Town of Black Mountain Staff Report
Board of Adjustment

Case No: S-25-02 **Hearing Date:** October 15, 2025
Case Name: 399 Blue Ridge Rd **Procedure:** Special Use Permit Evidentiary Hearing

Request:
The applicant is seeking a Special Use Permit to develop the parcel as a Planned Unit Development consisting of what the applicant describes on their application as "50 deeply affordable dwellings." The development is to be a mixture of single-family homes and duplexes.

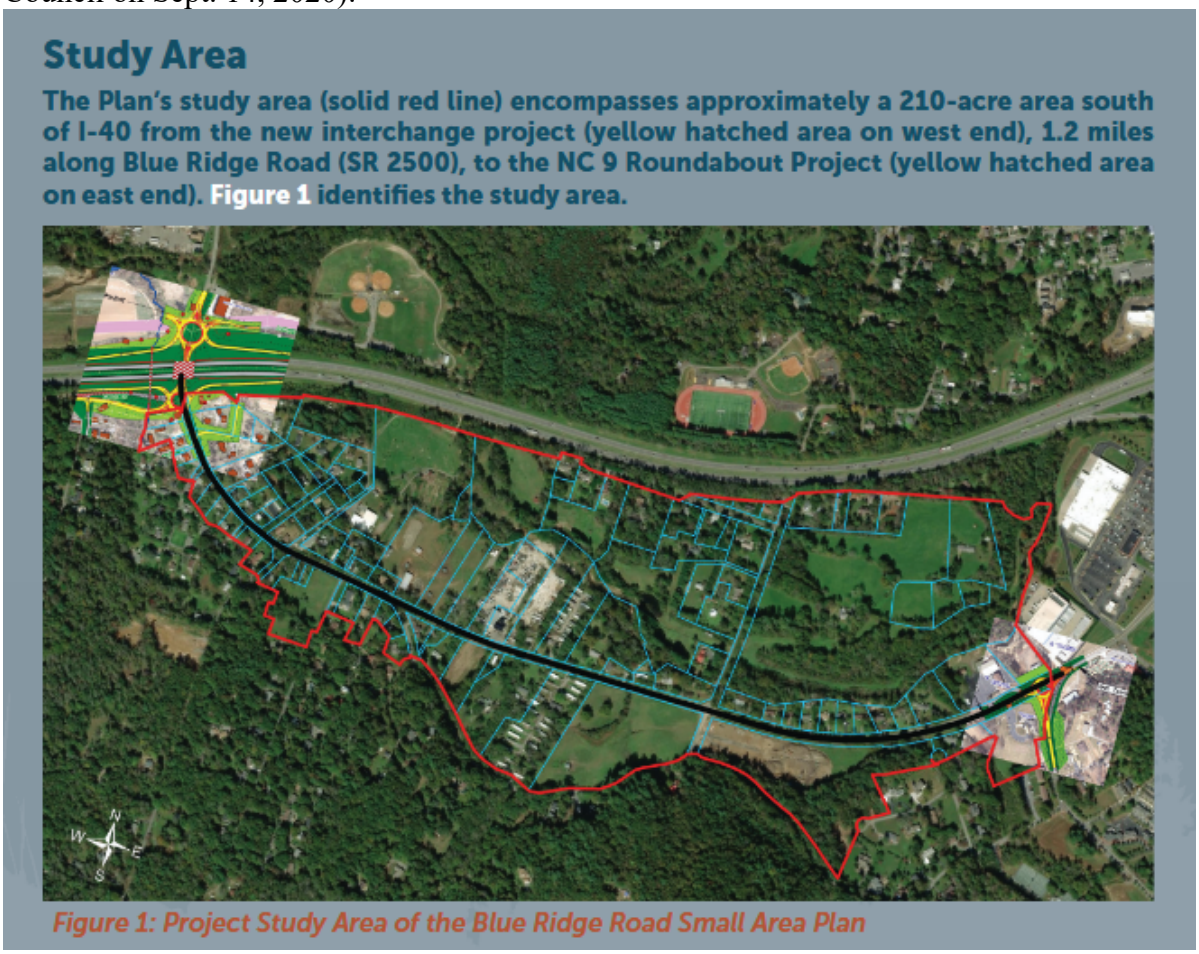
For this checklist item, the applicant wrote: "N/A – Proposed internal greenway connections are shown in place of sidewalks." The site plan does depict – in green – **internal path connections**.

Given that the Blue Ridge Road Small Area Plan calls for a sidewalk and multiuse path along Blue Ridge Road, the Board of Adjustment should seek a **"sidewalk or greenway easement"** along the portion of the parcel that abuts Blue Ridge Road.

The site plan and landscape compliance plan do depict the required "internal pedestrian consideration" (The site plan includes the same green-shaded path that was labeled *Pedestrian Trail* in the previously-submitted version. The revised version is missing the label; the label *Pedestrian Trail* should be added.)

The Board should seek the provision to the Town of **"a minimum eight-foot sidewalk right-of-way"** along the "abutting town dedicated street" of Old Lakey Gap Road.
